FERMI-2

AMENDMENT TO FACILITY OPERATING LICENSE

Amendment No. 44  
License No. NPF-43

ATTACHMENT TO LICENSE AMENDMENT NO. 44

FIGURE 3.2.3-1

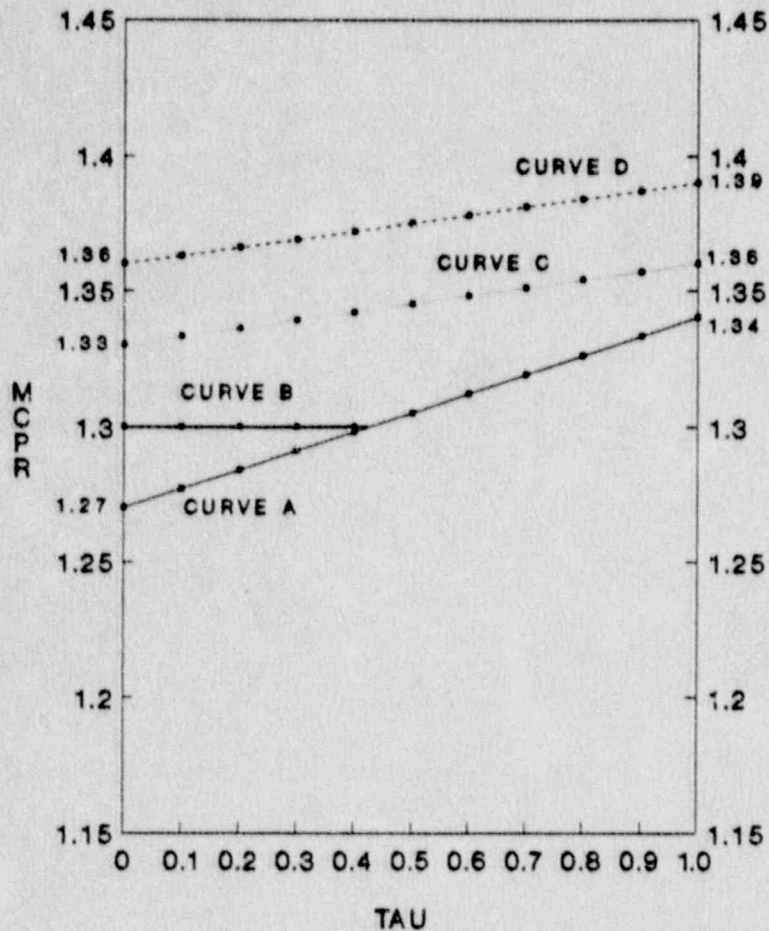
BOC TO 12,700 MWD/ST  
 MINIMUM CRITICAL POWER RATIO  
 (MCPR) VERSUS TAU AT RATED FLOW

- CURVE A - MCPR limit for CCC operational mode with both turbine bypass and moisture separator reheater in service.
- CURVE B - MCPR limit for non-CCC operational mode with both turbine bypass and moisture separator reheater in service.
- CURVE C - MCPR limit for both CCC or non-CCC operational modes with either turbine bypass or moisture separator reheater out of service.
- CURVE D - MCPR limit for both CCC or non-CCC operational modes with both turbine bypass and moisture separator reheater out of service.

FIGURE 3.2.3-1A

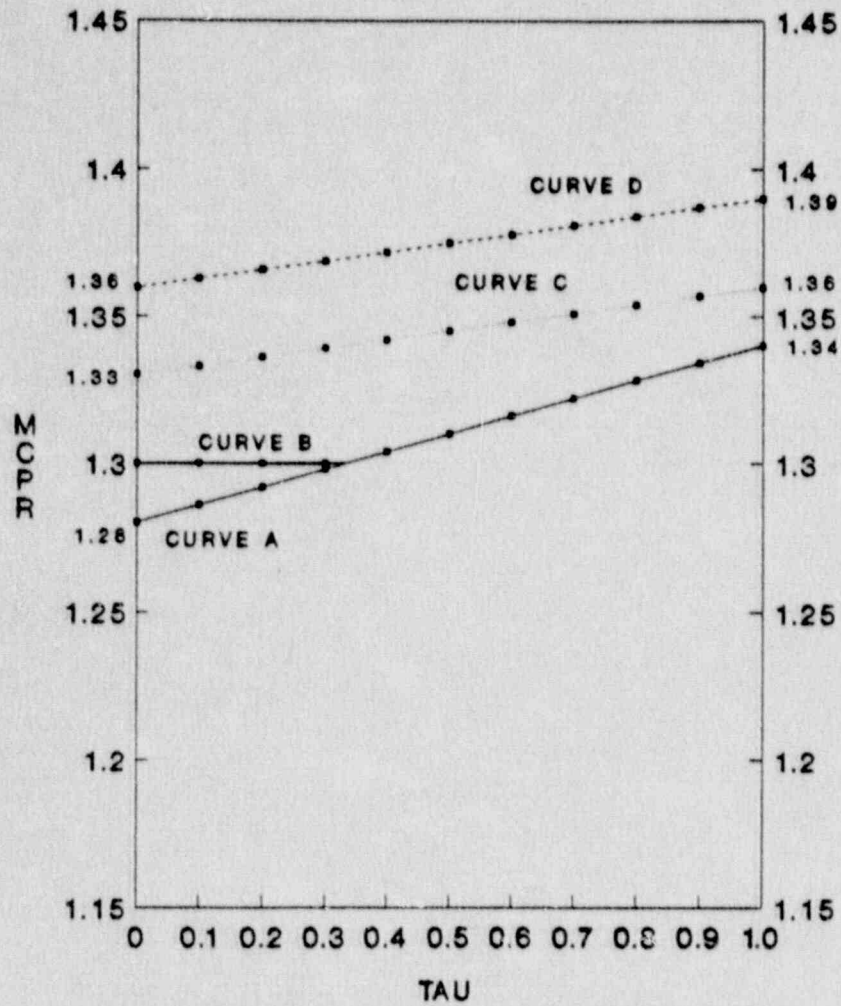
12,700 MWD/ST TO 13,700 MWD/ST  
 MINIMUM CRITICAL POWER RATIO  
 (MCPR) VERSUS TAU AT RATED FLOW

- CURVE A - MCPM limit for CCC operational mode with both turbine bypass and moisture separator reheater in service.
- CURVE B - MCPM limit for non-CCC operational mode with both turbine bypass and moisture separator reheater in service.
- CURVE C - MCPM limit for both CCC and non-CCC operational modes with either turbine bypass or moisture separator reheater out of service.
- CURVE D - MCPM limit for both CCC or non-CCC operational modes with both turbine bypass and moisture separator reheater out of service.

FIGURE 3.2.3-2

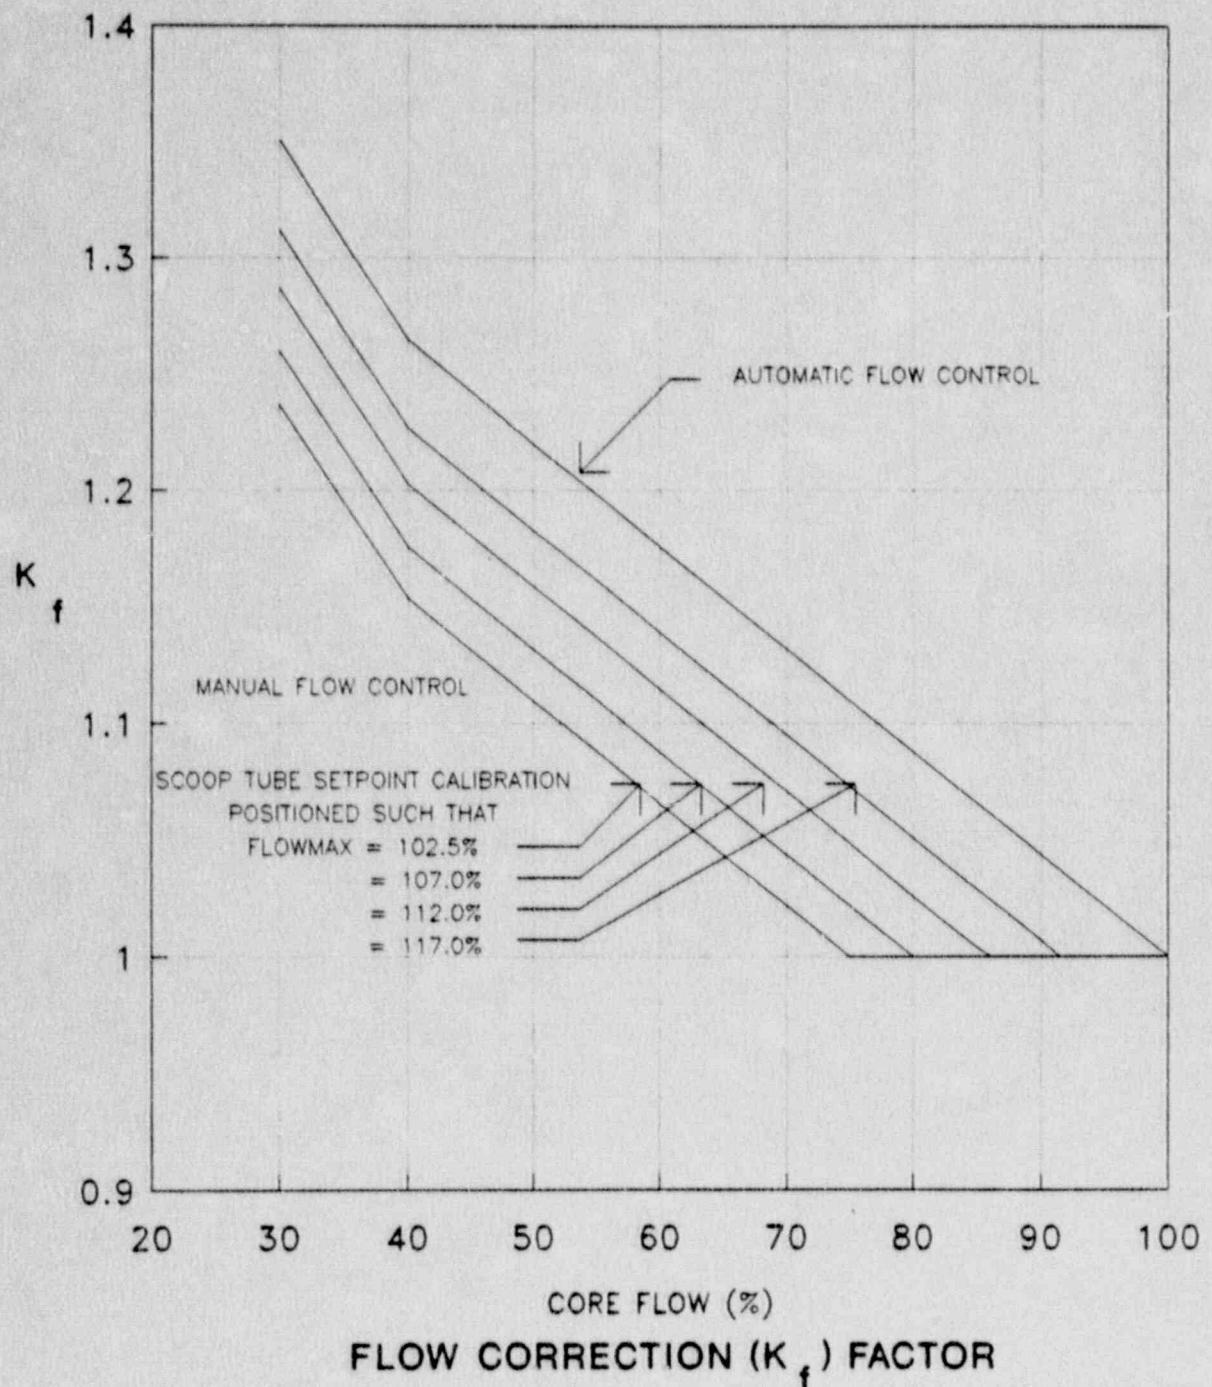
The purpose of the  $K_f$  factor of Figure 3.2.3-2 is to define operating limits at other than rated core flow conditions. At less than 100% of rated flow the required MCPR is the product of the MCPR and the  $K_f$  factor. The  $K_f$  factors assure that the Safety Limit MCPR will not be violated during a flow increase transient resulting from a motor-generator speed control failure. The  $K_f$  factors may be applied to both manual and automatic flow control modes.

The  $K_f$  factor values shown in Figure 3.2.3-2 were developed generically and are applicable to all BWR/2, BWR/3, and BWR/4 reactors. The  $K_f$  factors were derived using the flow control line corresponding to RATED THERMAL POWER at rated core flow, although they are applicable for the extended operating region.
